UNITED STATES PATENT AND TRADEMARK OFFICE

10/534,961

Office Action Summary	Application No. 10/534,961	Applicant(s) KADOKURA, MASAHIKO	
	Examiner SANJAY CATTUNGAL	Art Unit 3768

DETAILED ACTION

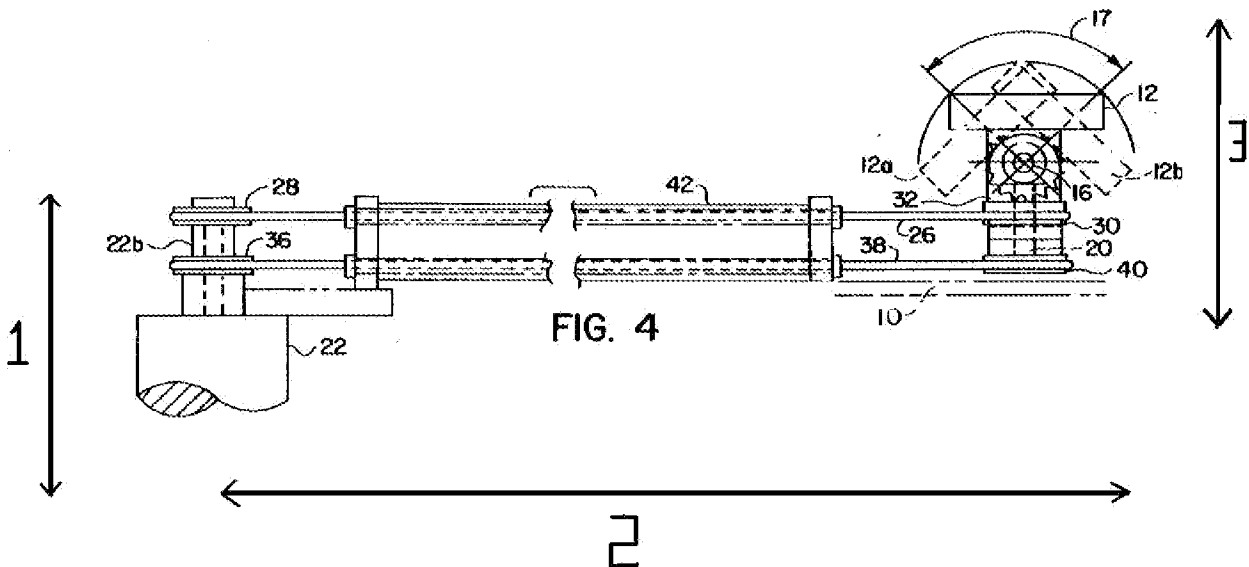
4. Rello further teaches that the shaft is oriented such that its longitudinal direction is parallel to a direction in which the motor and the transducer is connected (fig. 2 and fig. 4).

5. Rello reference fig. 2 and fig. 4, as shown has three longitudinal axis as shown in the figure above using the three arrows. Axis 1 is the longitudinal direction of the shaft 22b. Axis 2 is the direction between the pulleys. Axis 3 is the longitudinal direction of shaft 20. Shaft 20 and Shaft 22b are parallel to each other. The claim recites that the shaft is oriented such that the longitudinal direction (Axis 1) is parallel to a direction in

which the motor and the transducer is connected. Since the motor and transducer are connected via Axis 2 and Axis 3. Taking the broadest reasonable interpretation Axis 3 is parallel to Axis 1 as such the claim limitations have been met.

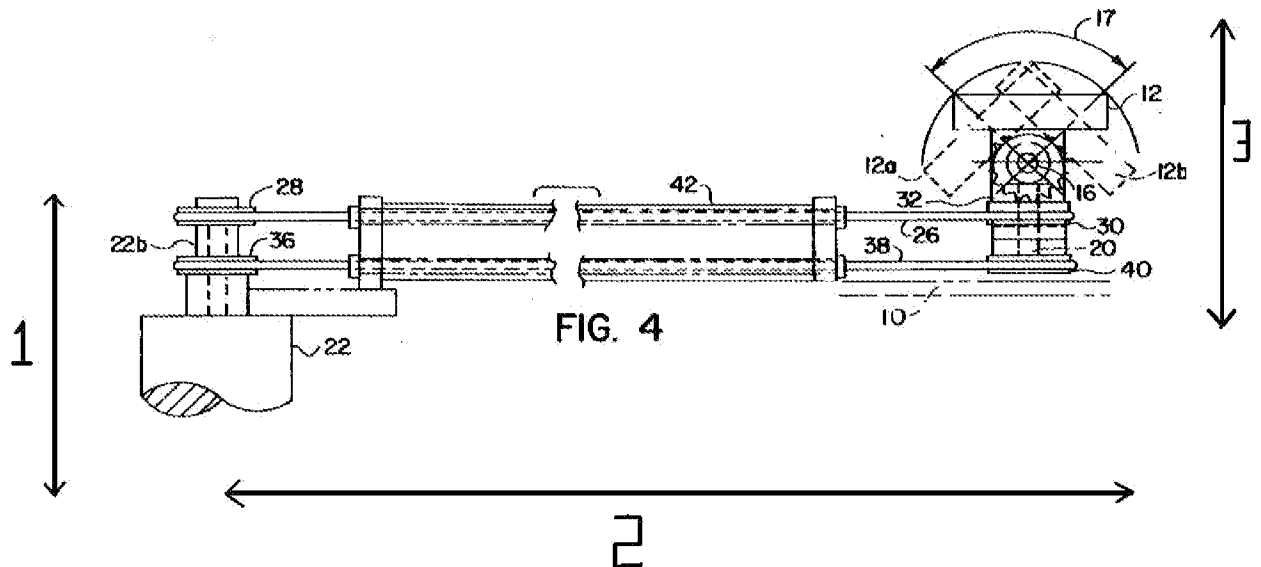
14. Applicant argues that Rello does not teach that the shaft is oriented such that its longitudinal direction is parallel to a direction in which the motor and the transducer is connected.

15. Examiner would like point out that Rello further teaches that the shaft is oriented such that its longitudinal direction is parallel to a direction in which the motor and the transducer is connected (figs. 2 and 4).

17. Rello reference fig. 2 and fig. 4, as shown has three longitudinal axis as shown in the figure above using the three arrows. Axis 1 is the longitudinal direction of the shaft 22b. Axis 2 is the direction between the pulleys. Axis 3 is the longitudinal direction of shaft 20. Shaft 20 and Shaft 22b are parallel to each other. The claim recites that the shaft is oriented such that the longitudinal direction (Axis 1) is parallel to a direction in

which the motor and the transducer is connected. Since the motor and transducer are connected via Axis 2 and Axis 3. Taking the broadest reasonable interpretation Axis 3 is parallel to Axis 1 as such the claim limitations have been met, and the rejection is made **FINAL**.
